BAR Meeting
January 27, 2010

ISSUE: Addition and Alterations

APPLICANT: Alabama Avenue LC by Stephen Kulinski, JLB Architects

LOCATION: 314 North Fayette Street

Figure 2: Proposed first demo and addition plan.

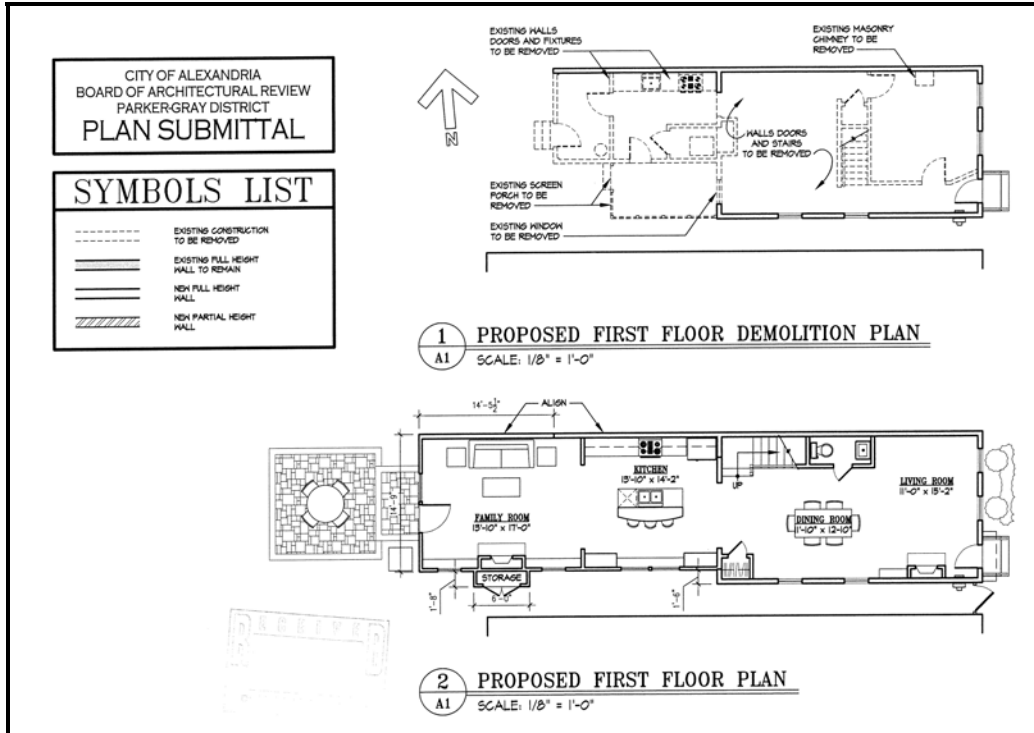
1. That the tool shed located within the required side yard on the south be deleted;
2. That fiber cement siding be used only on the addition, including the north elevation of the addition, and that it be smooth and the nails should not show in the installation;

The proposed two story addition, fence and covered entry comply with the Zoning Ordinance. The proposed first floor storage area is located within the required south side yard must either be deleted or relocated.

Figure 4: Proposed demo and alterations front elevation.

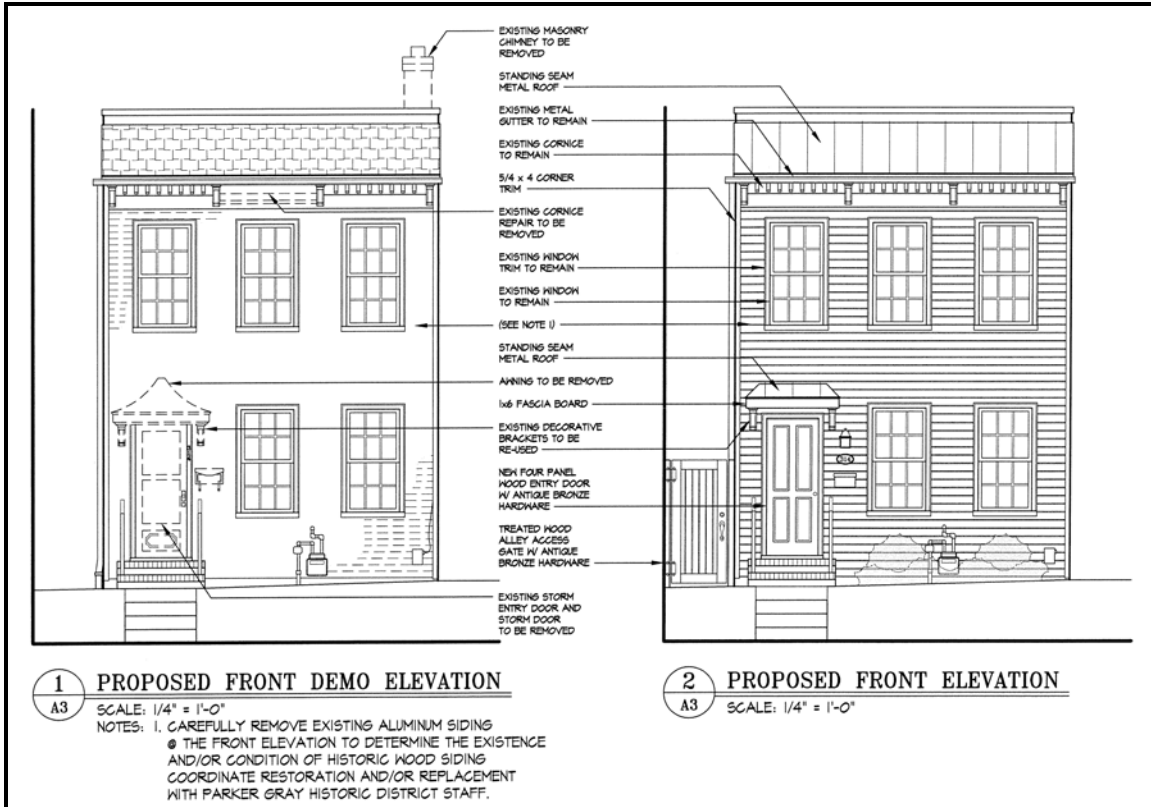
It appears that the front awning over the front entrance to the house is historic, although it is unclear if it dates to the construction of the house. The applicant believes that the framing of the awning is historic, but that the pagoda-style roof was added at a later date. Staff would encourage the applicant to retain the entire awning and repair/replace where necessary. In the opinion of Staff, this is a unique feature and it gives the relatively modest home some unusual character in the Parker-Gray historic district.

The *Design Guidelines* strongly encourage the retention of historic chimneys because they are such a character defining features in the historic district. Staff does not object to the demolition of the chimney located toward the rear of the house, but would prefer to see the chimney at the front of the house retained. Staff understands that the new interior layout of the house makes this difficult; however, Staff strongly encourages the applicant look at ways to preserve the chimney in situ.

Staff is not aware of any historic precedent for standing seam metal on front mansard roofs in the historic districts. Instead, a common turn-of-the-20th century mansard roof material would have been stamped metal shingles. Staff recommends the use of stamped metal shingles instead of standing seam metal on the front roof.

Figure 7: Proposed demo and addition north elevation.

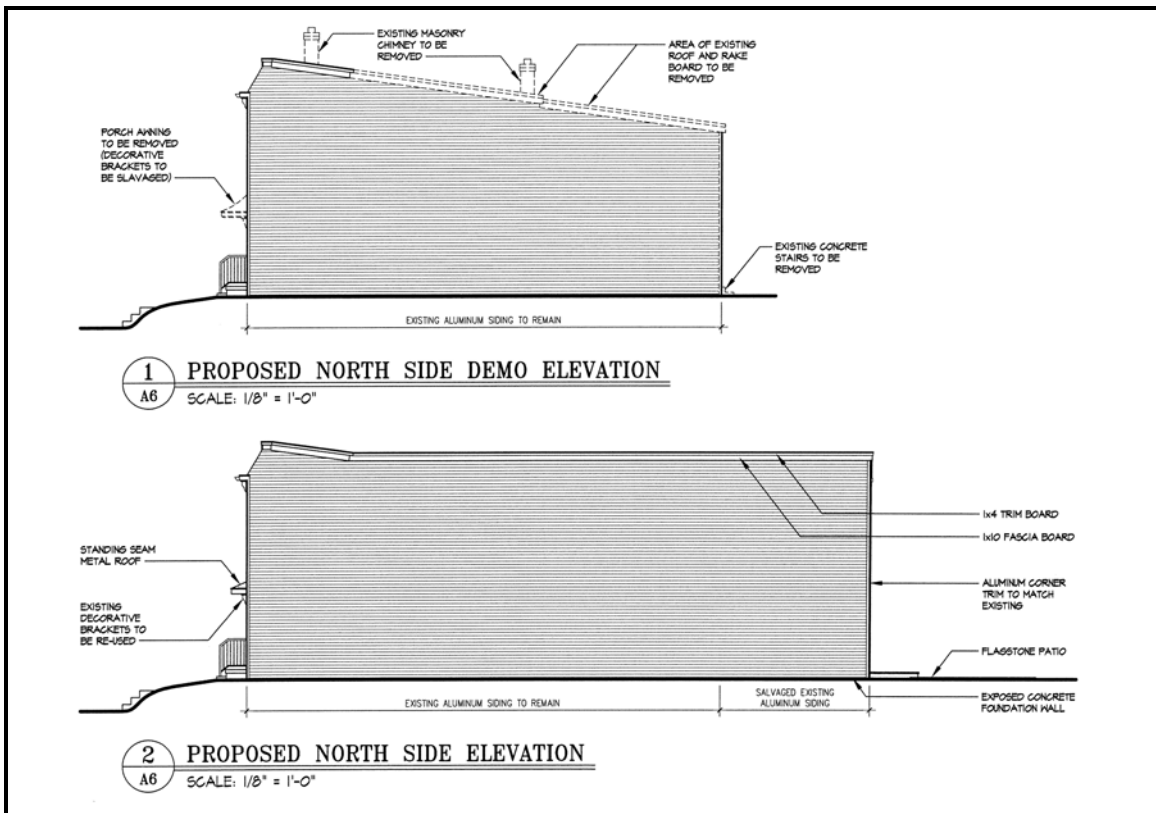
3. That a vertical trim board be added between the historic portion of the house and the new addition on the north elevation;
4. That the simulated divided light wood windows on the addition be either two-over-two or one-over-one, not six-over-six as shown on the plans;

Although Staff supports the use of recycled aluminum on the upper north elevation of the historic house where the roof is being raised, Staff would prefer to see fiber cement siding also used on the north elevation of the addition, with a vertical trim board added to differentiate between the historic house and the addition. Should the Board approve the use of recycled siding on the north elevation of the addition, Staff still recommends that a vertical trim board be added between the existing and proposed construction.
